4. Russian Gap Subdivision 2023 Addition; KPB File 2022-185 Johnson Surveying / Tarcy, Coulliette, Byrd Location: Russian Gap Road Cooper Landing Area / Cooper Landing APC

RUSSIAN GAP SUBDIVISION 2023 ADDITION PRELIMINARY PLAT

ITEM 4 - RUSSIAN GAP SUBDIVISION 2023 ADDITION

STAFF REPORT

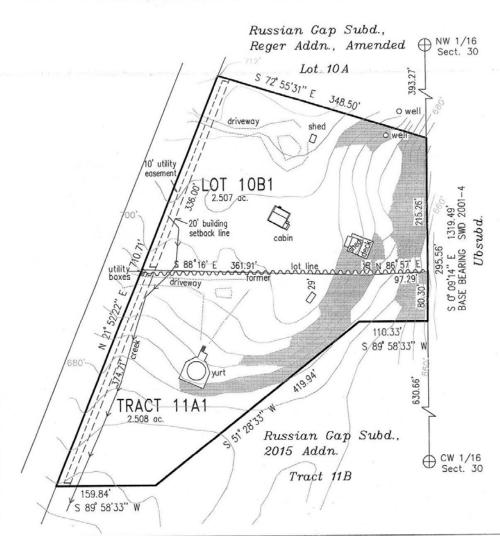
<u>Site Investigation:</u> Steep areas are present and shown. They are mostly within the eastern portion of the subdivision. *Staff recommends* the steep terrain be removed and plat note 5 remove the portion regarding contours.

There are low wet areas present along the western boundary. They are designated as kettle. The wetlands are not depicted but the surveyor has noted a creek is present and plat note 5 indicates it is the extent of the wet area. KPB GIS data does not indicate a creek within that area and parent plats did not indicate the creek. This may be the result of development. **Staff recommends** the creek and the plat note remain on the final plat and a wetlands determination note be added to the plat.

<u>Utility Easements</u> Russian Gap Subdivision, SW 2001-4, granted a 20 foot utility easement adjacent to the Russian Gap Road dedication. The easement was carried over onto the replats. *Staff recommends* the depiction, labeling, and notes be revised to carry over the 20 foot utility easement.

Staff recommendation: Update Tract 10B to "Lot". Remove "Amended" from the parent subdivision name.

- Staff recommendation: Label Russian Gap Road and provide a right-of-way width label.
- D. A vicinity map, drawn to scale showing location of proposed subdivision, north arrow if different from plat orientation, township and range, section lines, roads, political boundaries, and prominent natural and manmade features, such as shorelines or streams:

- **Staff recommendation:** Include the boundary and a label for Chugach National Forest. Center the section numbers.
- G. The status of adjacent lands within 100 feet of the proposed subdivision boundary or the land status across from any dedicated rights-of-way that adjoin the propose subdivision boundary, including names of subdivisions, lot lines, block numbers, lot numbers, rights-of-way; or an indication that the adjacent land is not subdivided:

- **Staff recommendation:** Remove "Amended" from the subdivision label to the north. Provide the depiction of Russian Gap Road and lots west of the right-of-way.

- Staff recommendation: There are some areas of kettle. Not shown but a creek is depicted.

Staff recommendation: Per code all setbacks shall be depicted. Per the code for RR LOZD, the property is subject to the following setbacks, 60 foot front, 25 side lot lines, and 40 rear. Provide depiction and labels and provide a reference to the plat note for setbacks.

- Plat note 1 Remove to provide new notes stated above.
- Plat note 3 "These lots are within Russian Gap Subdivision Local Option Zoning District with notice recorded with the Seward Recording District in Book 110 Page 725, amendments within Serial Number 2011-000638, 2011-000909-0, and 2020-001405-0."
- Plat note 4 add "...and Book 111 Page 105."

Plat note 5 - remove "Contour interval 4'." Leave the remainder of the note on the final.

Staff recommendation: Make sure the signature lines indicate the former lot the owner is signing. Comply with 20.60.190.
